148. PLCA Reconciliation Sublayer (RS)

148.4.7 Dynamic PLCA (D-PLCA)

Figure 148–3—PLCA Control state diagram, part a

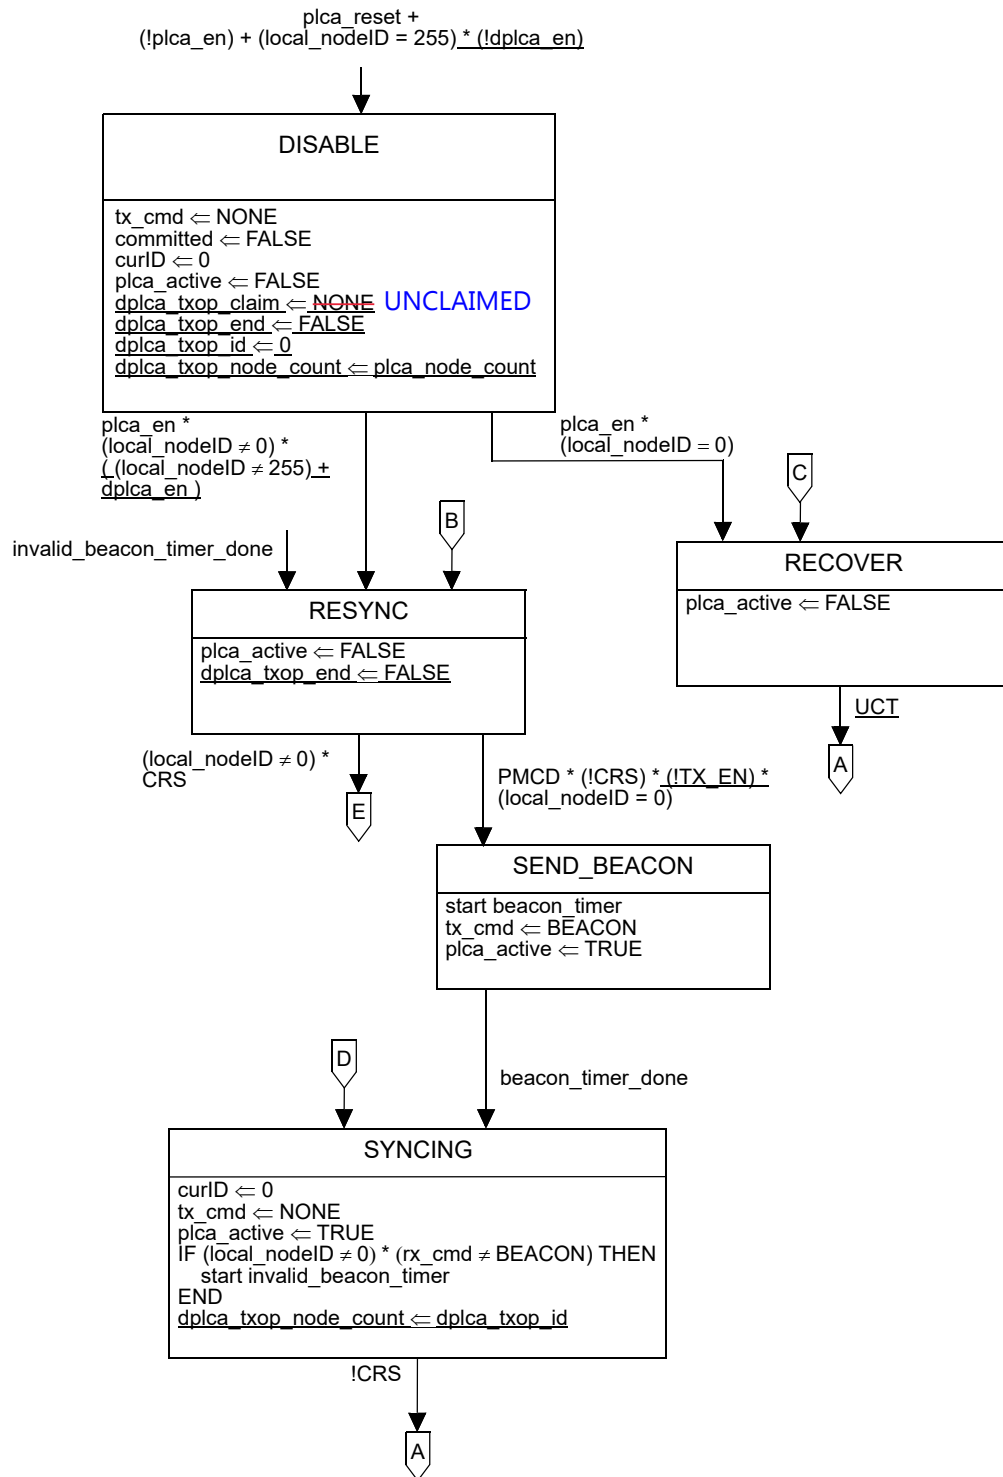
Replace the arc from BURST to TRANSMIT in Figure 148-4 with tag F, replace the arc and the text “ELSE” from NEXT_TX_OPPORTUNITY to WAIT_TO in Figure 148-4 with tag G, and change Figure 148-3 and Figure 148-4 as shown:

Figure 148-5—PLCA Data state diagram, part a

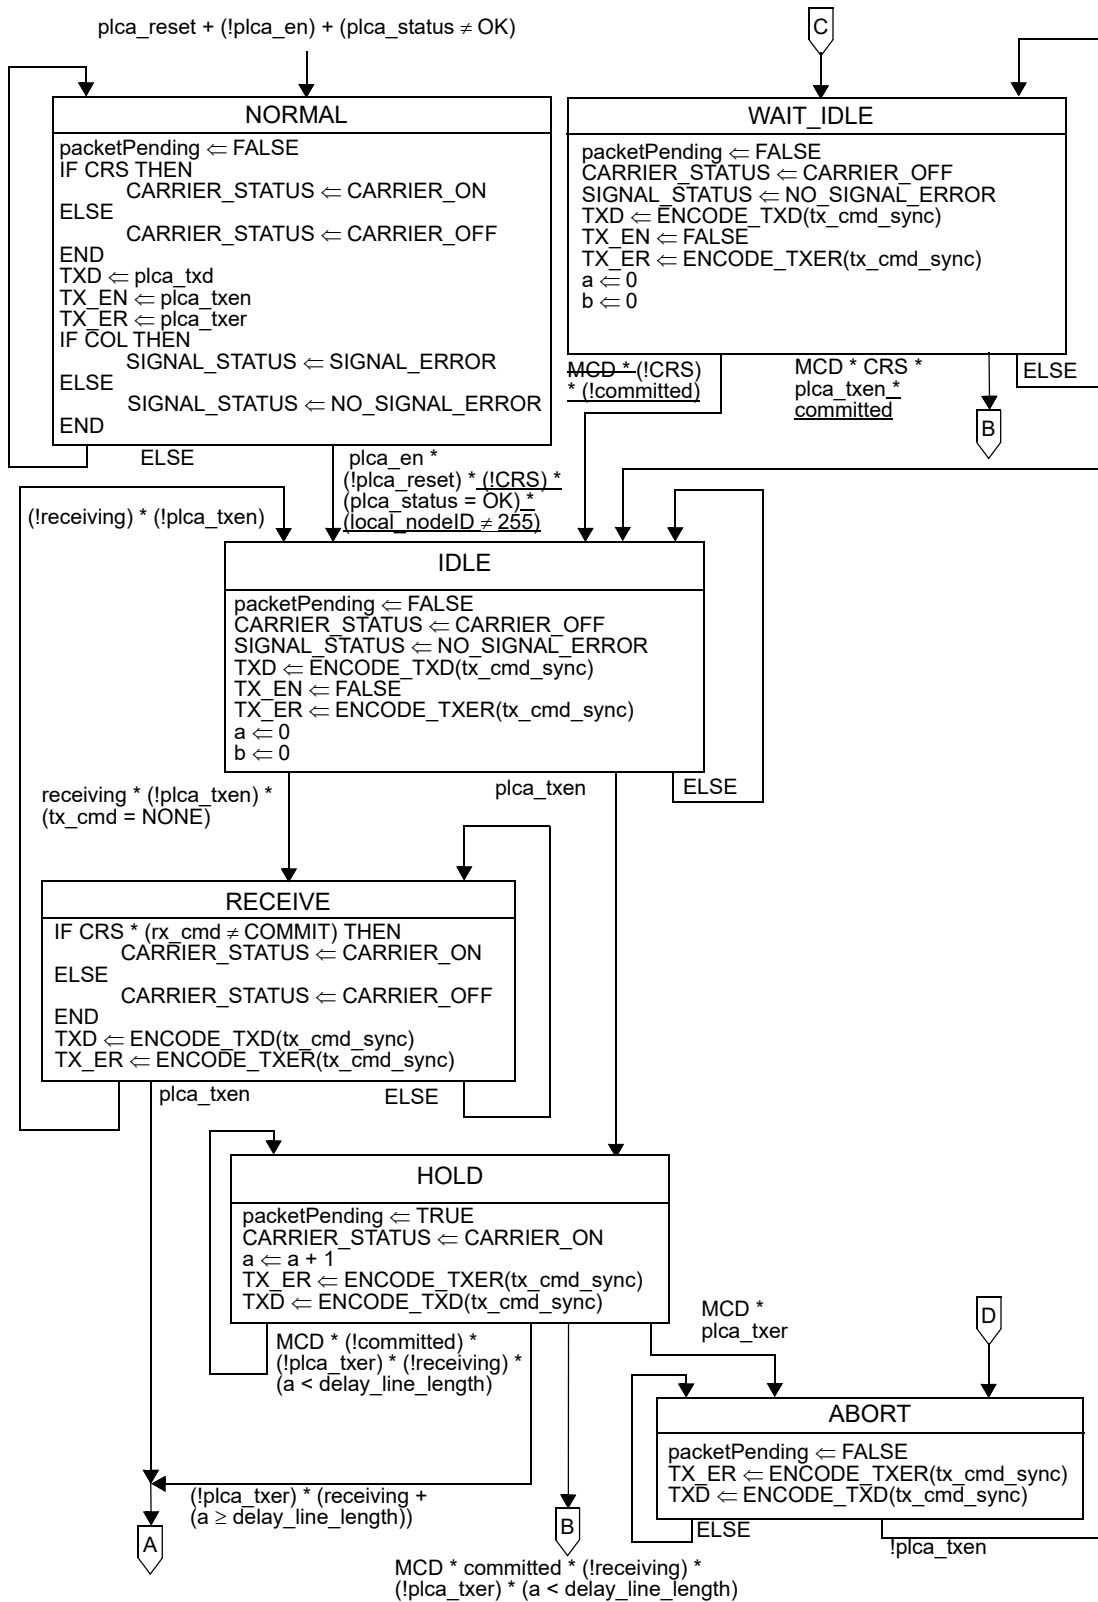
Change Figure 148-5 and Figure 148-6 as shown:

Figure 148–8—D-PLCA Control State Diagram

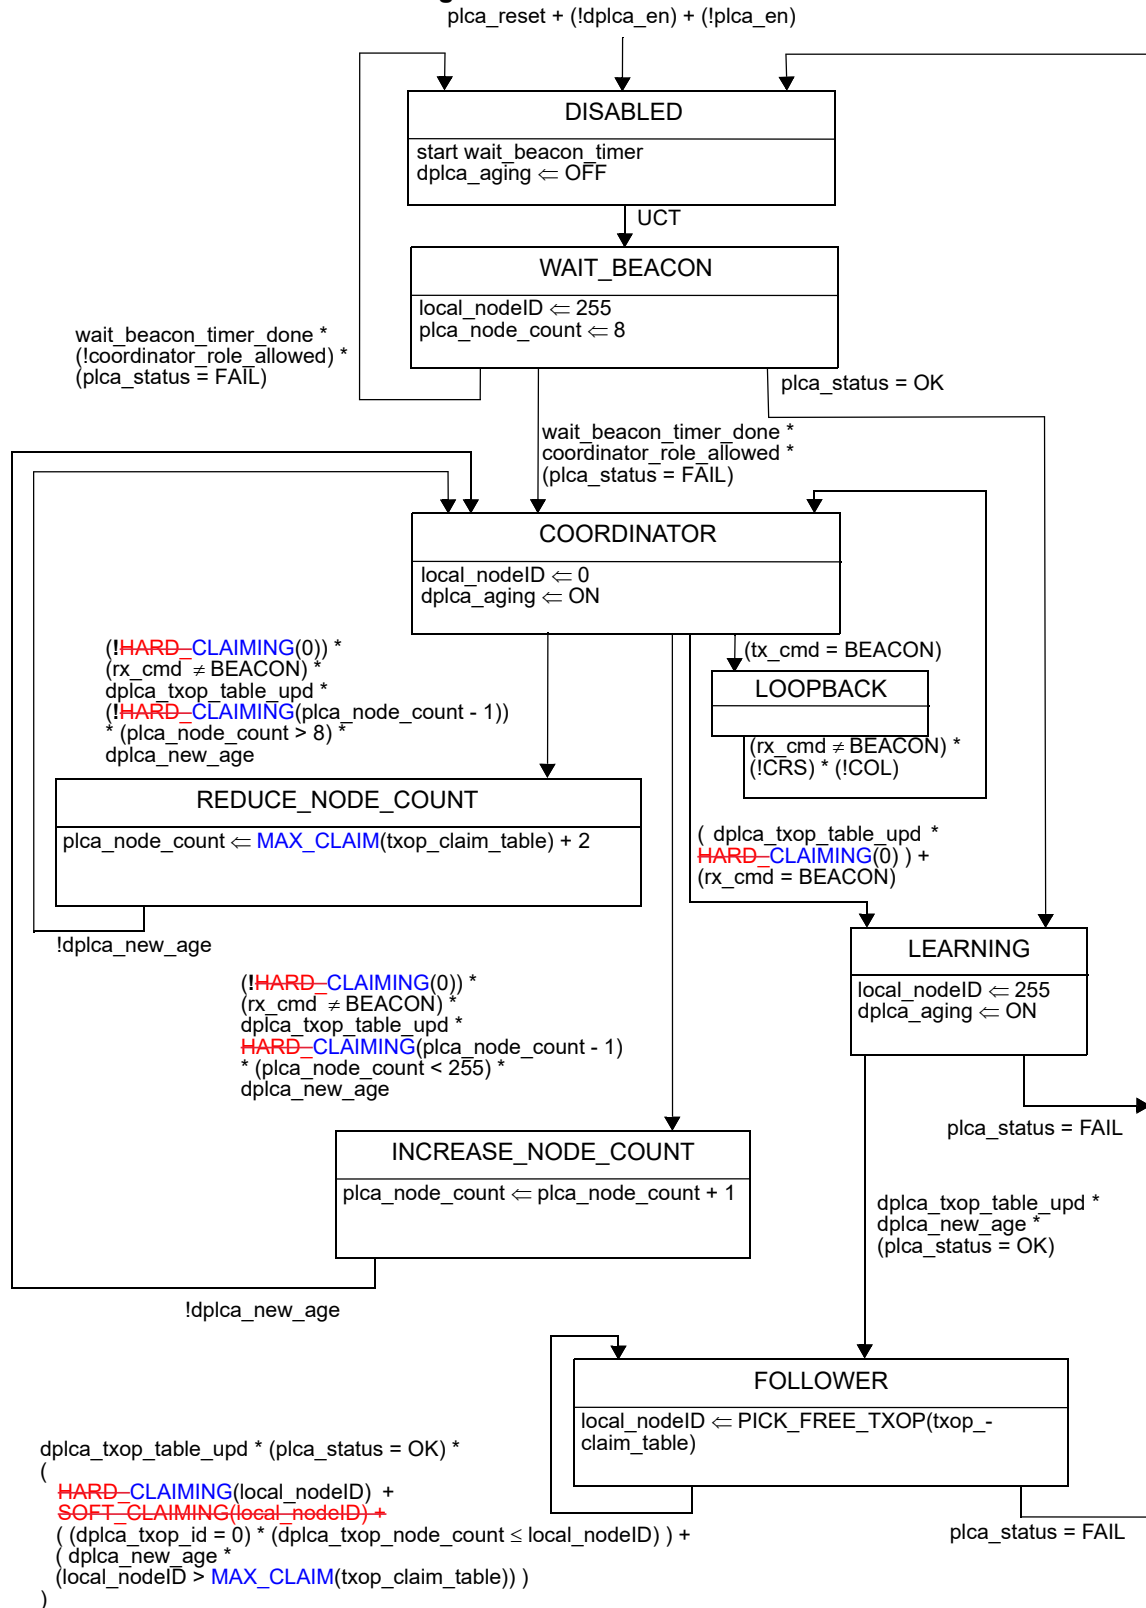
Insert new subclause 148.4.7 (and Figures 148-8 and 148-9) after 148.4.6 (and its subclauses) as follows:

D-PLCA is an optional feature of the PLCA RS that reduces the amount of configuration required to use PLCA. D-PLCA enables nodes to select unique node IDs automatically and defines a method to designate a single node with ID = 0 (coordinator). If the D-PLCA option is implemented, it shall comply with the state diagrams in Figure 148-8 and Figure 148-9.
